OFFICIAL NOTIFICATION
Under the U.S. Federal Boat Safety Act

NUMBER: 83-28

TR, TRS, 215E and 215H GIMBAL RING FIX

Figure 1. "Square Swivel Shaft" Type Gimbal Ring

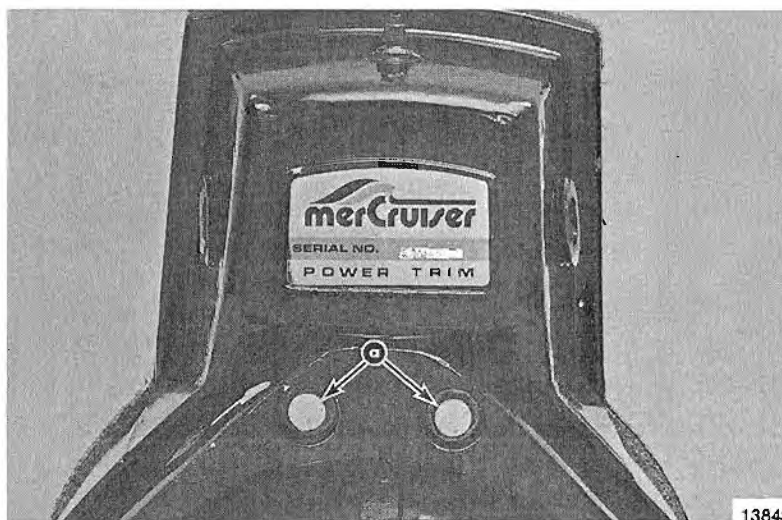
It has come to our attention that the gimbal ring on some MerCruiser TR, TRS, 215E and 215H Stern Drives could crack where it connects to the swivel shaft. If this should occur, it could cause loss of steering control.

The potential problem is isolated to stern drives equipped with "square swivel shaft" type gimbal rings. (Figure 1) These gimbal rings were used as original equipment on newer TR and TRS models (with transom assembly Serial No. 6037486 and above). The gimbal ring also was included in Swivel Shaft Kit (93305A1), which was designated for use on 215E, 215H and older TR and TRS models.

A Clamp Bracket Kit (41456A1) is to be installed on all units equipped with the "square swivel shaft" type gimbal ring. (Figure 2)
